REFERENCE:	TSB: 23-060-23 GROUP 23 - Body	Date:	May 24, 2023	REVISION:	-
VEHICLES AFFECTED:	2023 (WL) Jeep Grand Cherokee This bulletin applies to vehicles built on or after October 05, 2022 (MDH 1005XX) and on or before January 27, 2023 (MDH 0127XX).	MARKET APPLICABILITY:			
CUSTOMER SYMPTOM:	The left, right or both front door nameplates or flags are not adhering (loose) to the door panel. Letters may have fallen off (Fig. 1) from the nameplate assembly.				
CAUSE:	Adhesion issue.

Fig. 1
Nameplate Assembly Letter "C" Missing Example

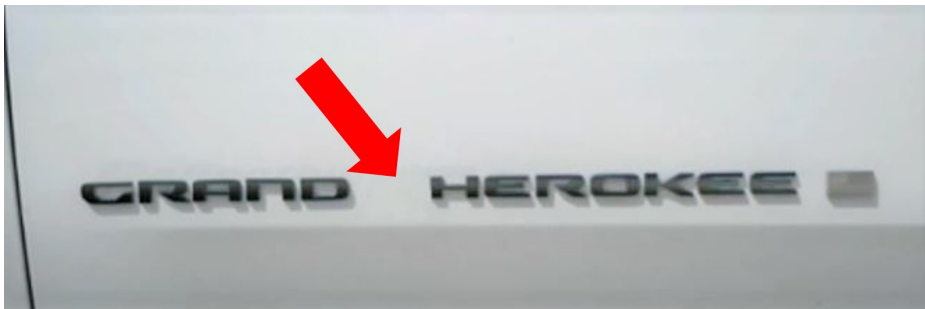
1. Visually inspect both front door nameplate assemblies for missing letters/flag (Fig. 1) .
2. Did one or both of the front door nameplate assemblies have missing letters/flag (Fig. 1) ?
 - YES>>> Replace the front door nameplate assemblies as required. Proceed to [Step 1](#) of the Repair Procedure.
 - NO>>> Proceed to [Step 3](#).
3. Using a 0.25 mm (0.0098 in.) gap gauge, verify for a proper gap between the nameplate assembly letters/flag and both front door panels.
4. Did any of the front door nameplate assembly letters/flag (Fig. 1) have a gap larger than 0.25 mm (0.0098 in.)?
 - YES>>> Replace the front door nameplate assemblies as required. Proceed to [Step 1](#) of the Repair Procedure.
 - NO>>> This bulletin has been completed, use inspect LOP (23-01-18-9E) to close the active RSU.

1. Using a trim stick tool, remove the nameplate assembly letters/flag carefully from the front door.
2. Wipe the attachment area with a clean, lint-free cloth, moistened with a 50% solution of water and alcohol, to thoroughly clean all residue from the front door nameplate assembly attachment surface area. Wipe dry the areas immediately with a dry, lint-free cloth.
3. Remove the protective covering from the back of the nameplate letters/flag and position the nameplate assembly onto the front door.

NOTE: To ensure proper nameplate adhesion, apply consistent and uniform pressure of approximately 40 p.s.i. over the entire surface of the nameplate letters/flag.

4. Visually inspect that there is 100% adhesion all around the perimeter of the nameplate assembly to the front door.
